APPENDIX C – COORDINATION WITH US 97 NORTH CORRIDOR PROJECT

Subject: City of Bend Comments for North End Alternatives

ODOT US 97 North End Corridor Project

City of Bend Review Comments - July 2008

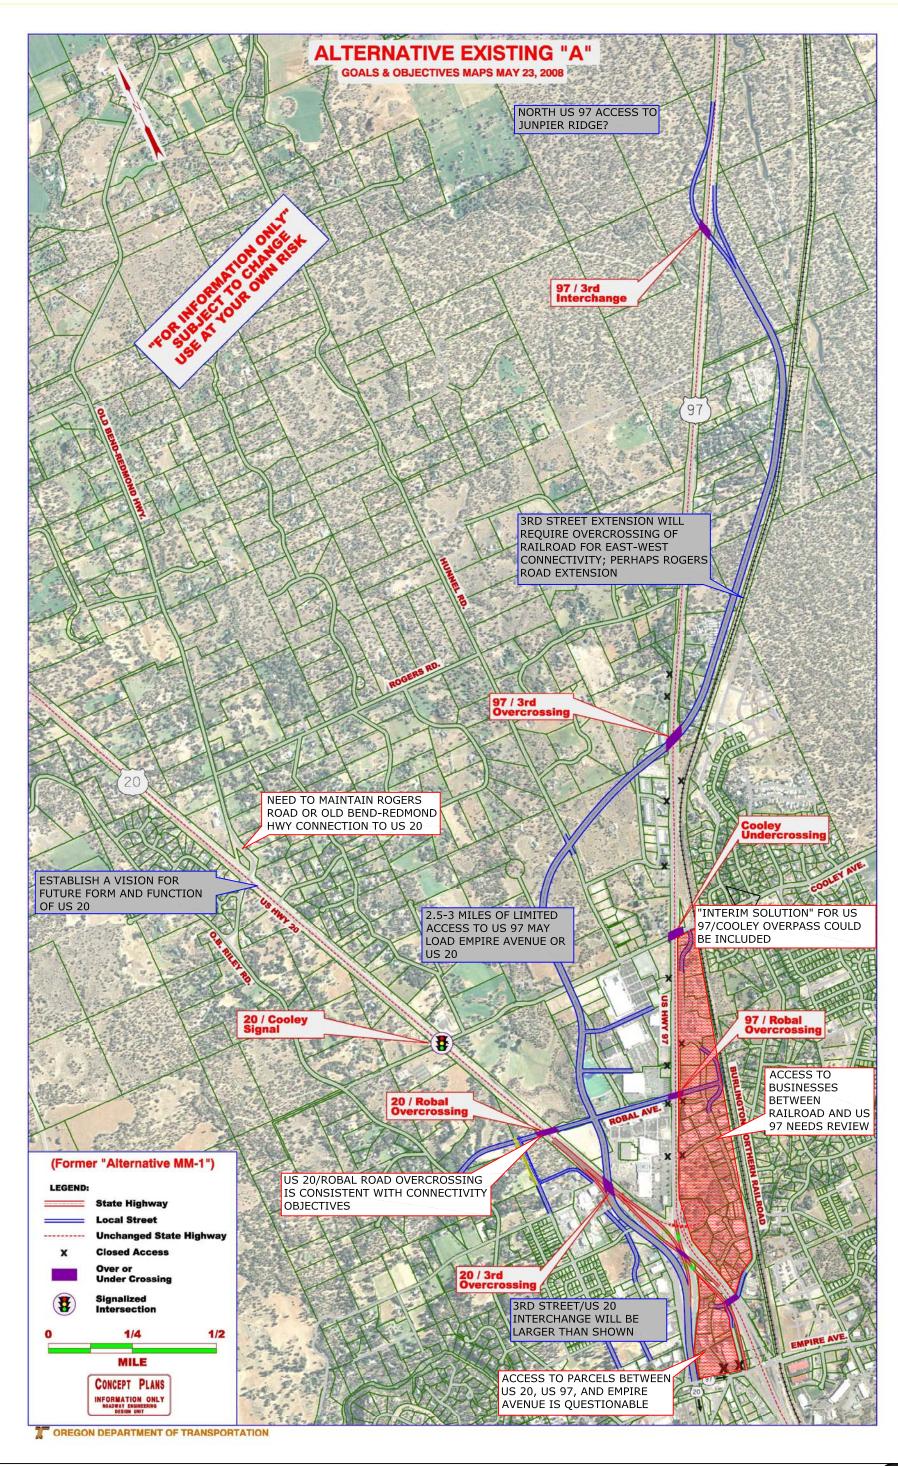
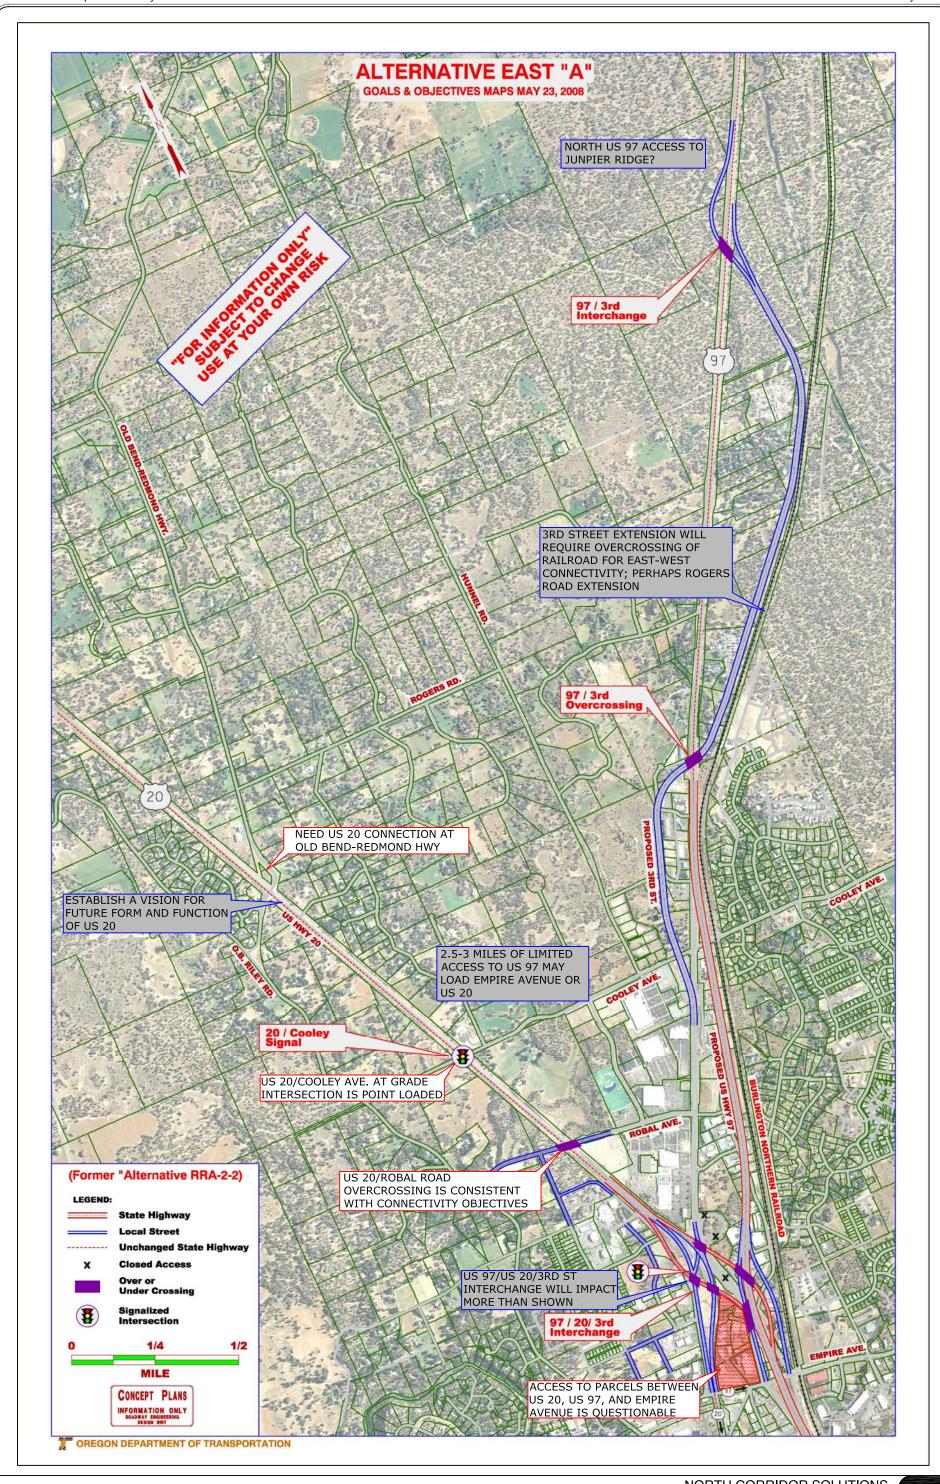
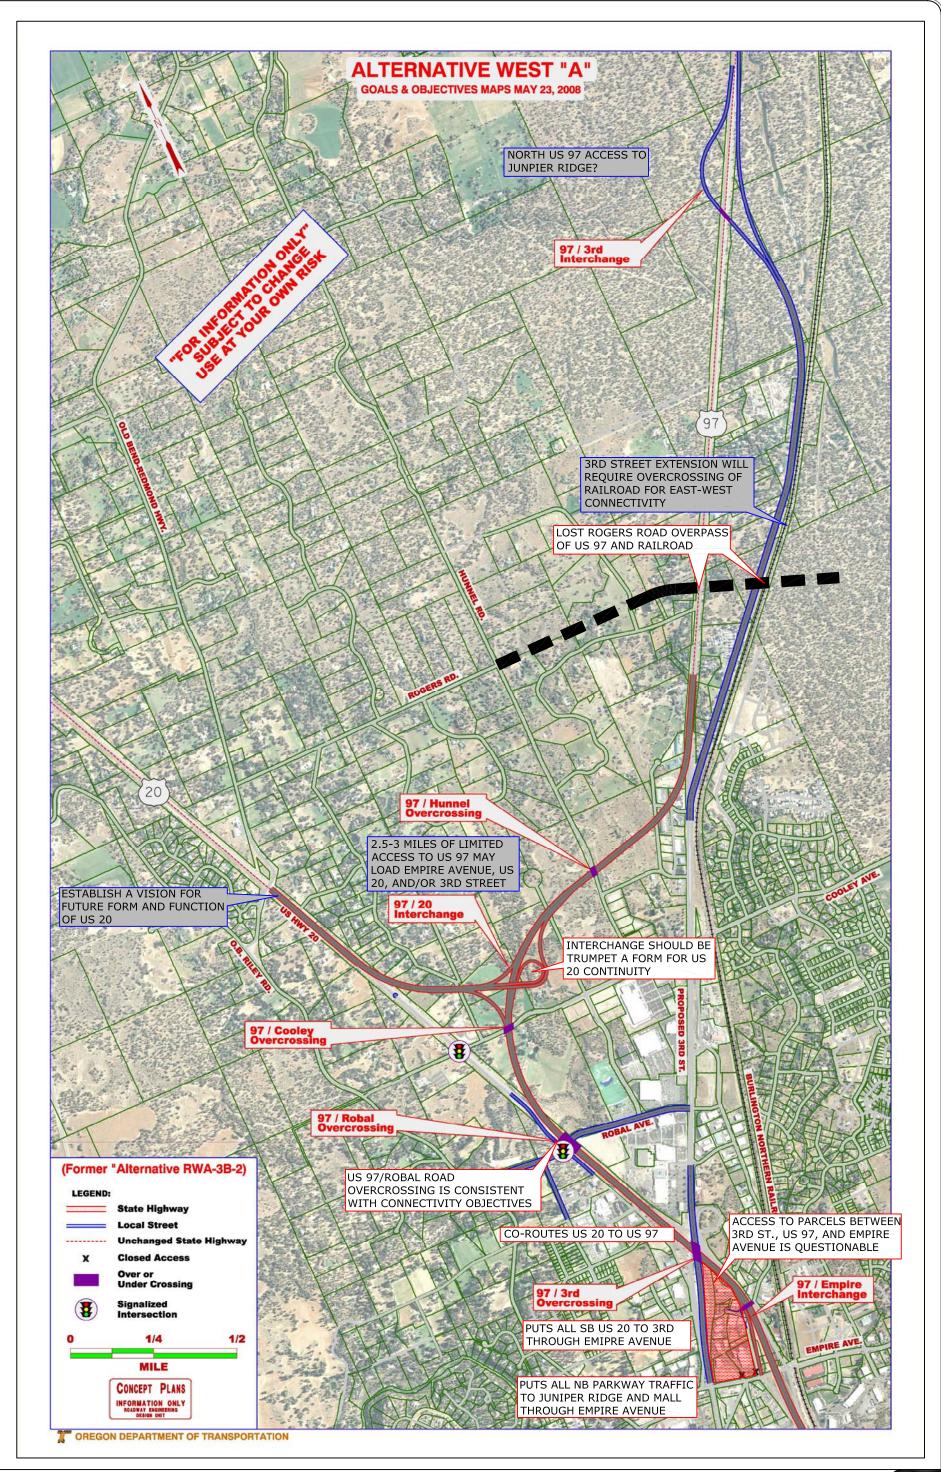
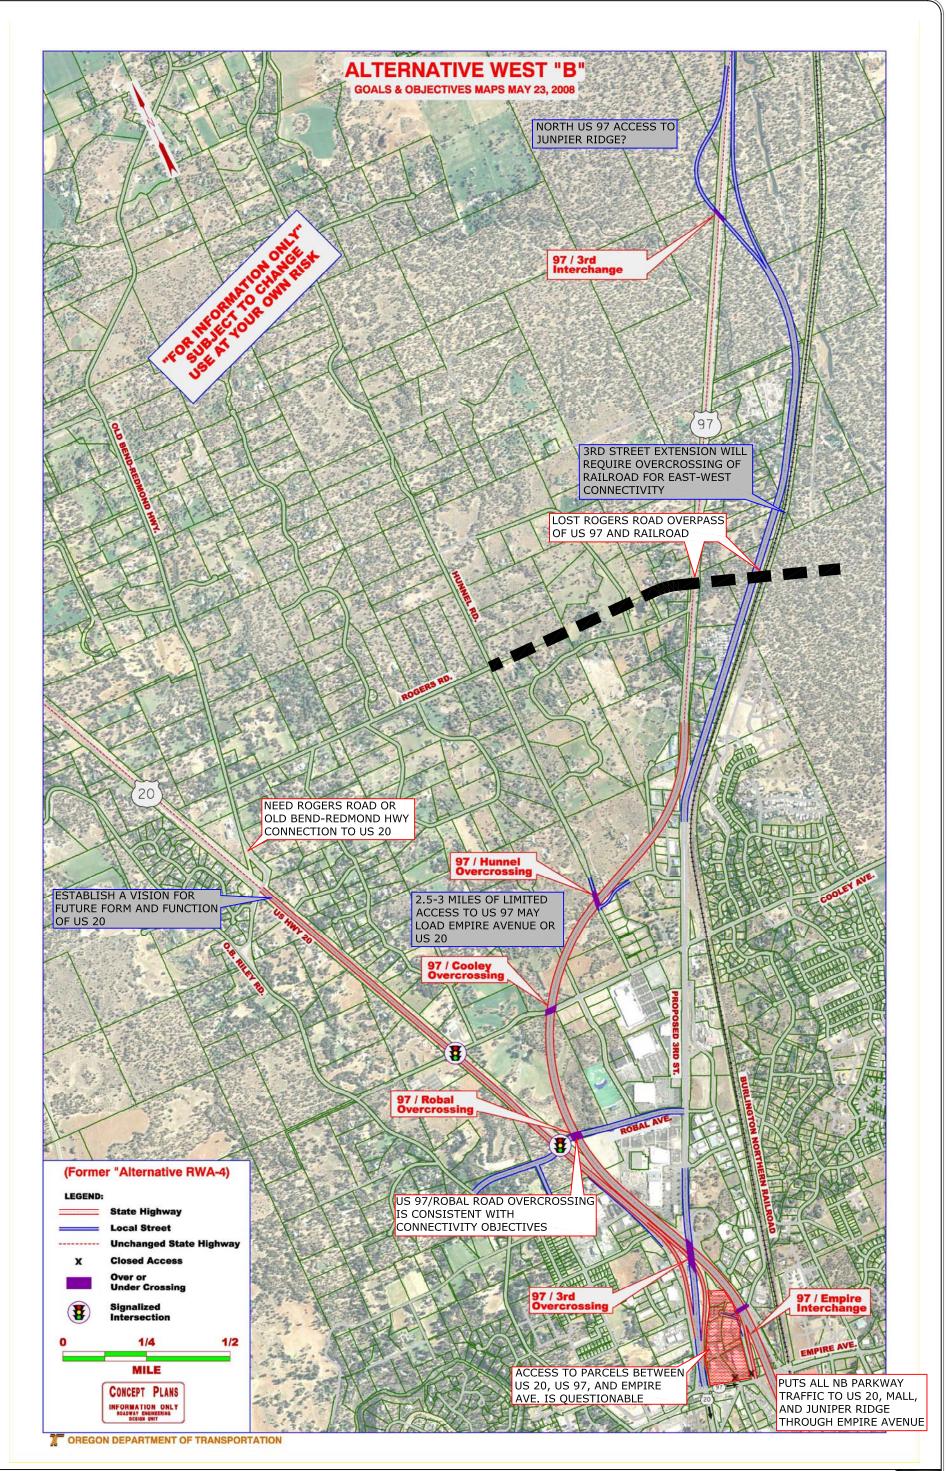
- Existing A (formerly MM1)
 - o This concept formerly terminated near Rodgers Road
 - Access to the lands between US 97 and the RR between Cooley and Empire requires significant review. Access to all these parcels, especially those north of Empire, east of US 20, and west of US 97 is suspect.
 - o This concept likely could still accommodate the US 97/Cooley overpass of the "interim solution" if desired in the future
 - New over crossing of US 20/Robal Road is consistent with NE Bend study connectivity objectives

- o This concepts appears to be highest ranking of TPAU Screening 1 efforts
- East A (formerly RRA-2-2)
 - o This concept likely point loads traffic through US 20/Cooley at grade intersection

- New over crossing of US 20/Robal Road is consistent with NE Bend study connectivity objectives
 - It is likely that the US 97/US20/3rd Interchange footprint will be significantly larger than shown to accommodate necessary grade separations, ramps, and merging lengths

- o Access to parcels north of Empire Avenue, east of US 20, and west of US 97 is suspect and requires review based on resultant ramp and interchange footprints

- West A (formerly RWA-3B-2)
 - This concept no longer shows the connectivity of a Rogers Road overpass of US 97 and RR
 - Concept co-routes US 20 to US 97 and combines their traffic flow south of Cooley Road

- This concept focuses traffic at the Empire Avenue interchange
 - Routes all northbound Parkway to Juniper Ridge and Mall traffic through the Empire Avenue ramps

- Routes all southbound US 20 to 3rd Street traffic through Empire Avenue ramps
 - The US 97/US 20 junction is shown as a Trumpet "B" form where a Trumpet "A" form is appropriate to serve US 20 directionally

- The foot print of the US 97/US 20 interchange is likely more impacting than shown
 - o The new over crossing of US 20/Robal Road is consistent with NE Bend study connectivity objectives

- Access to parcels north of Empire, east of US 20, and west of US 97 is suspect based on resultant ramp and interchange footprints
- West B (formerly RWA-4)

- This concept formerly terminated Clausen Drive
 - This concept no longer shows the connectivity of a Rogers Road overpass of US 97 and RR
 - This concept focuses traffic at the Empire Avenue interchange

- Routes all northbound Parkway to US 20, Juniper Ridge, and Mall traffic through the Empire Avenue ramps
 - Routes all southbound US 20 to southbound Parkway traffic through Empire Avenue ramps

- o New over crossing of US 20/Robal Road is consistent with NE Bend study connectivity objectives
- Access to parcels north of Empire, east of US 20, and west of US 97 is suspect based on resultant ramp and interchange footprints

NORTH CORRIDOR SOLUTIONS NEW EMERGENCY ROUTES BEND, OREGON

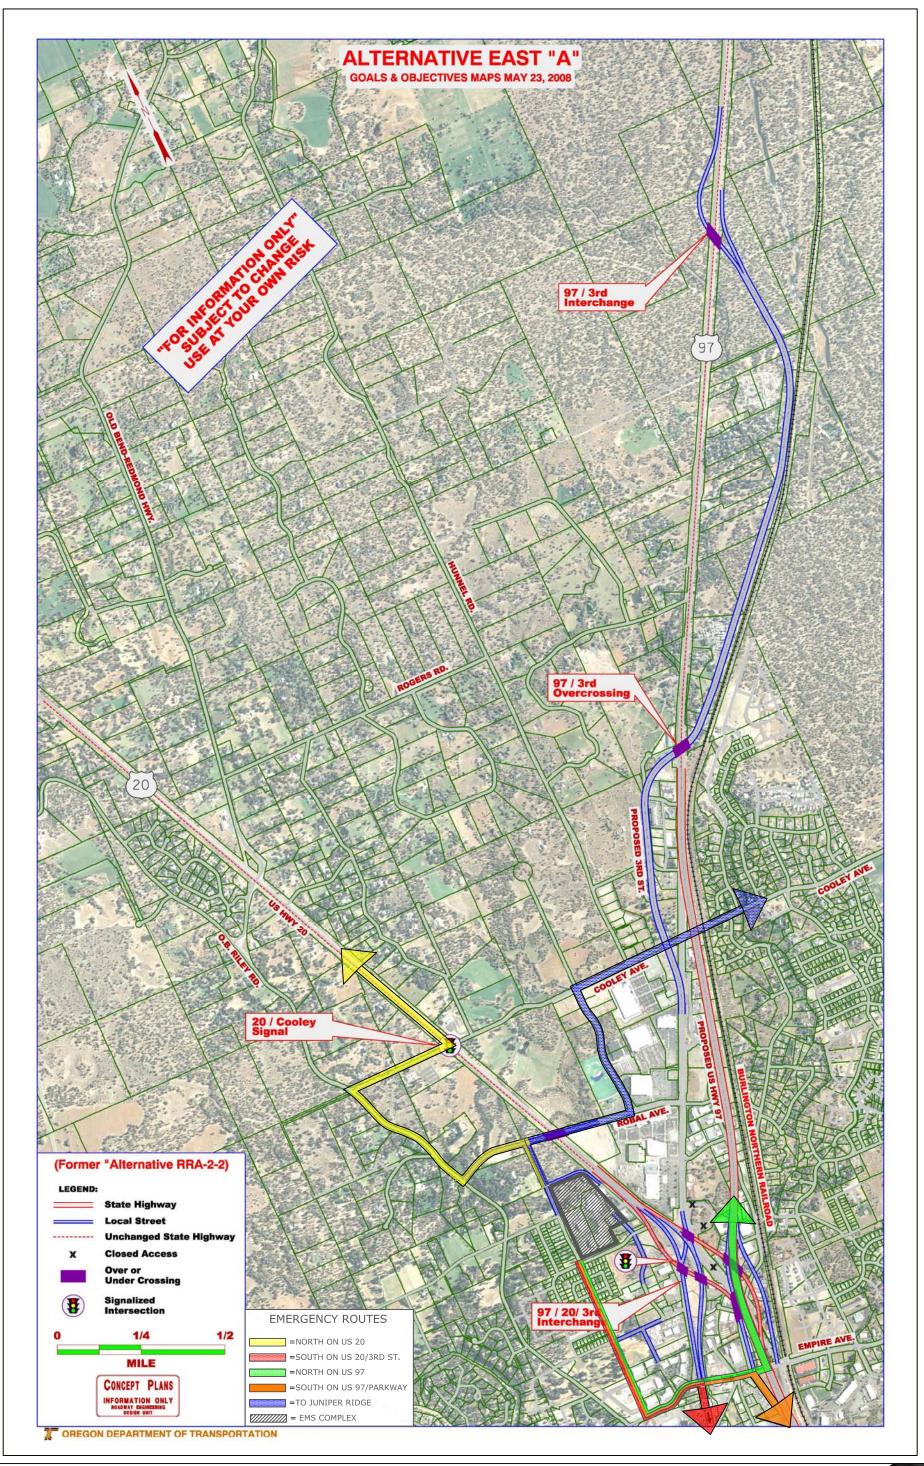
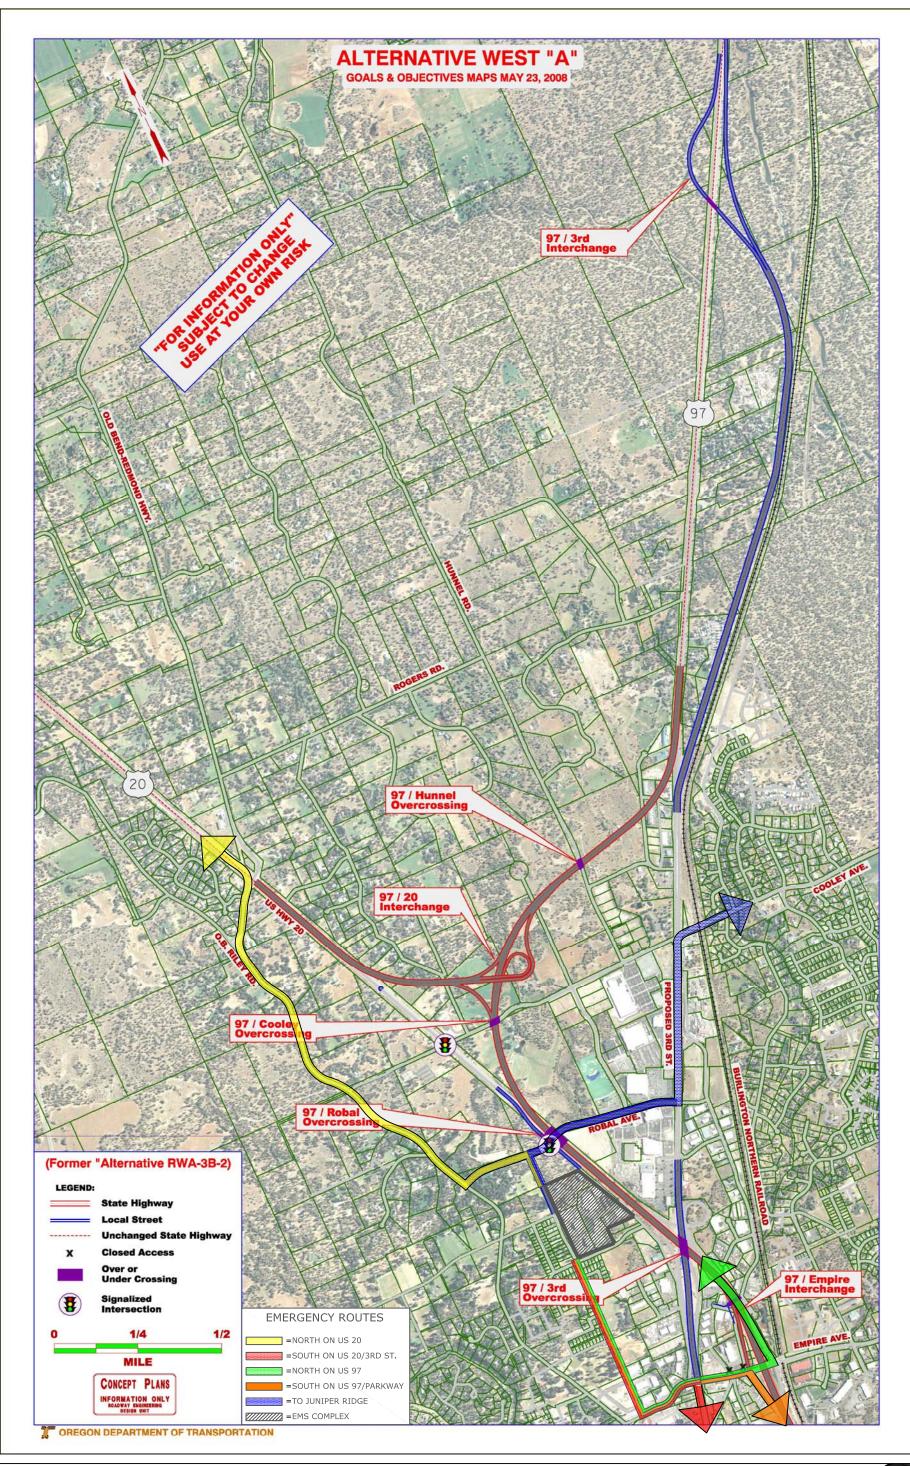
- The complex west of US 20 holds City Fire, County, Fire, Sherriff, State Police, and City Police, and 911 Dispatch uses
- There is a definite need to move in all directions in and out of their US 20 access point

- In the future, the providers will have to serve the Juniper Ridge area out of this site
- Current concepts all change their existing ability to exit out on US 20 and result in rerouting, the use back local roads, and out-of-direction travel

- o The new emergency service routes resultant from each of the alternatives are illustrated in Figures ER1 through ER4
- ODOT and the services providers have previously discussed a connection to NW Britta Street that would provide access to Robal Road as an access option
